**FINAL**  
**Mitigated Negative Declaration**  
**and Supporting Initial Study**  
for Pacific Gas and Electric Company's

**Embarcadero-Potrero 230 kV**  
**Transmission Project**

**(A.12-12-004)**

## NOTICE OF FINAL INITIAL STUDY/ MITIGATED NEGATIVE DECLARATION

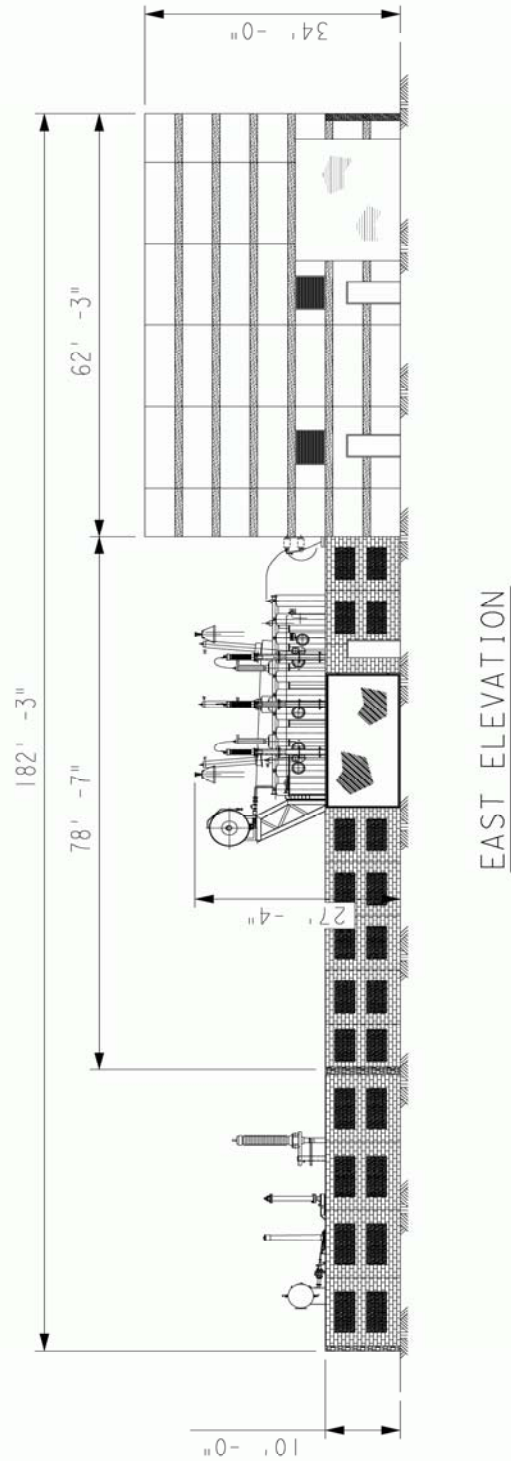
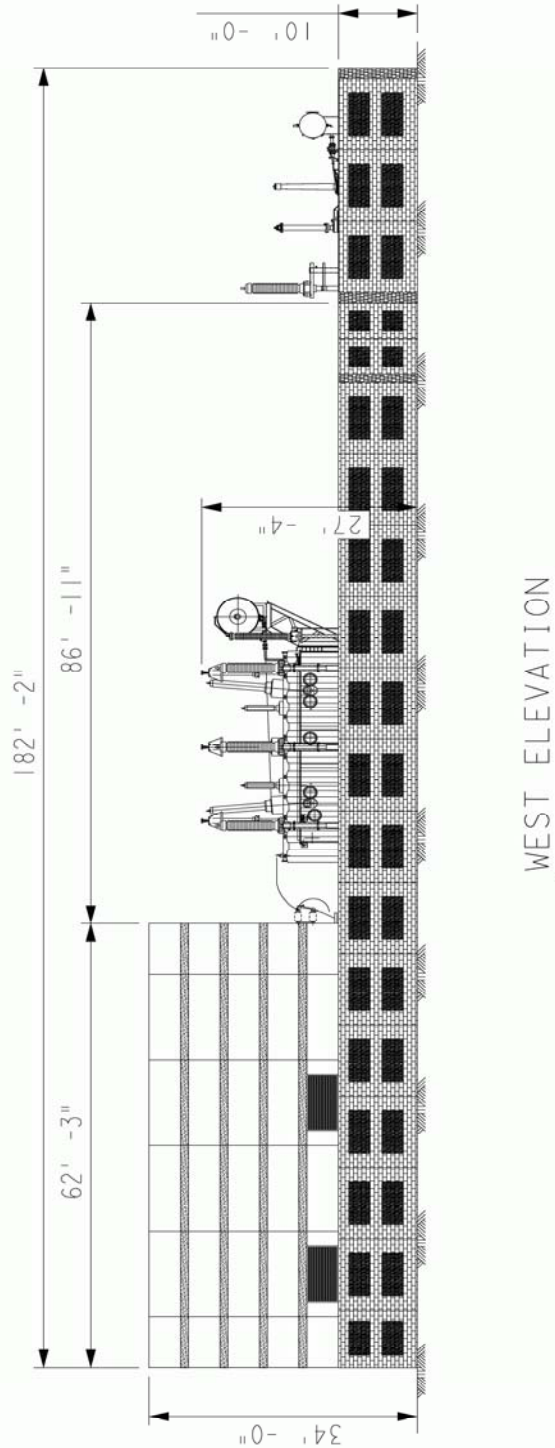
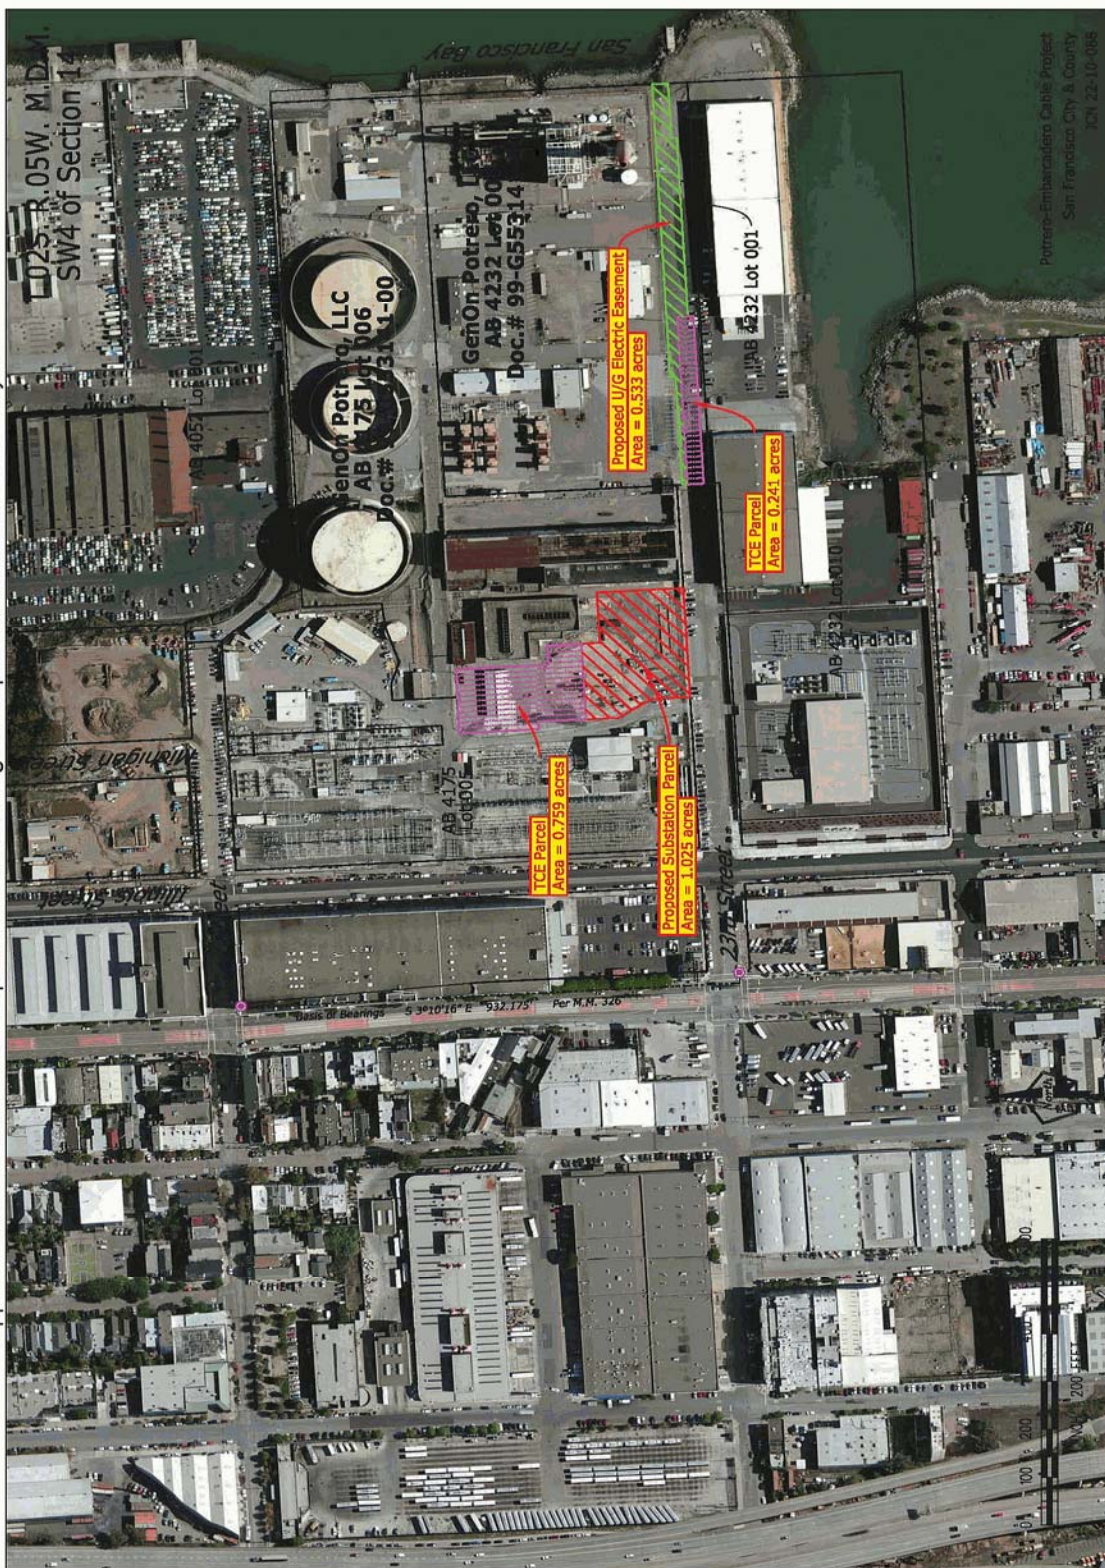
Additionally, the Commission should modify Figures 4-14 and 4-15 in the MND to be consistent with the updated drawings provided in Appendices C-G to this letter. Appendix C is a revised site plan for the switchyard. Appendices D-F are revised elevation drawings showing the current design profile looking toward the east, west, and north, respectively. Appendix G is an aerial view of the area with outlines showing the revised shape of the land rights PG&E intends to acquire from NRG (formerly GenOn), including the land needed for the switchyard and Alternative 1 for the construction staging site.

F-5 Figure 4-14 (Potrero Gas Insulated Switchgear Building Conceptual) and Figure 4-15 (230 kV Electrical Equipment) have been replaced in the Final IS/MND by revised figures submitted as Appendices C-G. The following new figures are included in the Final IS/MND:
